DEPARTMENT OF PLANNING AND ZONING

August 29, 2012

Re: Cummings Warehouse Hotel (220 S. Union Street)
DSUP#2012-0019
Concept Plan – Phase 1 & 2

Example Stairway Identification Sign

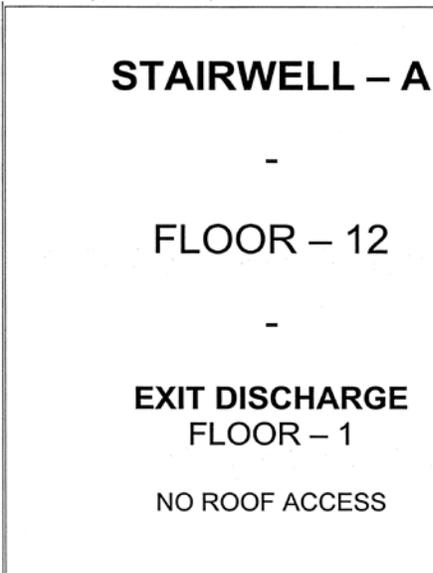
- C-7 Provide Stairway Identification. A sign shall be provided at each floor landing in interior vertical exit enclosures connecting more than three stories designating the floor level, the terminus of the top and bottom of the stair enclosure and the identification of the stair. The signage shall also state the story of, and the direction to the exit discharge and the availability of roof access from the stairway for the fire Department, in accordance with USBC 1020.1.6.

Stairway identification signs. Stairway identification signs shall be provided at each landing in all interior exit stairways connecting more than three stories. Stairways shall be identified by letter designation starting next to the main entrance with "A" and continuing in a clockwise or left to right pattern using consecutive letters of the alphabet for each additional stairway. Two copies of the stairway signs shall be submitted to the fire official for approval within 30 days of completion of construction or receipt of notification.

Sign requirements. Stairway signs shall designate the stairway letter, state the floor level, the level of exit discharge, and if there is access or no access to the roof regardless if the access door or roof hatch locks. The bottom of the sign shall be located five (5) feet above the floor landing in a position that is readily visible when the stairwell door is opened or closed. The signs must have lettering that is a minimum of 2 inches but no greater than 4 inches in height. This information may be stenciled directly onto the wall but all lettering must be of a color contrasting with the background stairway wall color. (See Figure 1020.1.6.1)

Footprint requirements. In buildings greater than three stories where there is no graphic representation of the building footprint, a simplified building schematic must be display in the lobby. The simplified building footprint shall be an overhead view of the buildings exterior and the general layout of the lobby of the first floor. Stairways shall be denoted by letter as stated in section 1020.1.6. (See Figure 1020.1.6.2)
